Product Change Notice (PCN)

PCN Number: PCN-0450726R-02

Product(s) Affected: PJ-002AH-SMT-TR & PJ-002BH-SMT-TR

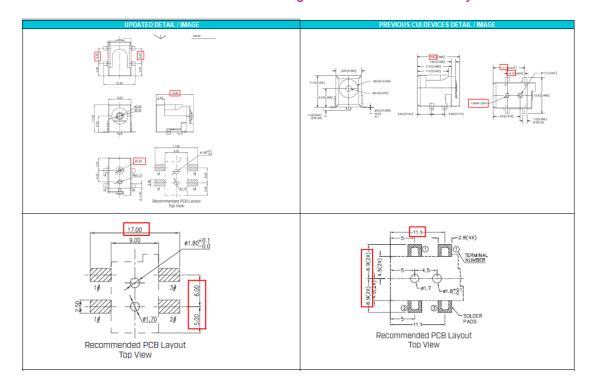
Description of Change:

- 1. Terminal spacing differs between terminals 2 & 3. Changed from oblong mounting post to circular.
- 2. PCB layout difference from 11.1mm vs 11mm
- 3. Insertion depth change from 8.9mm to 9.5mm
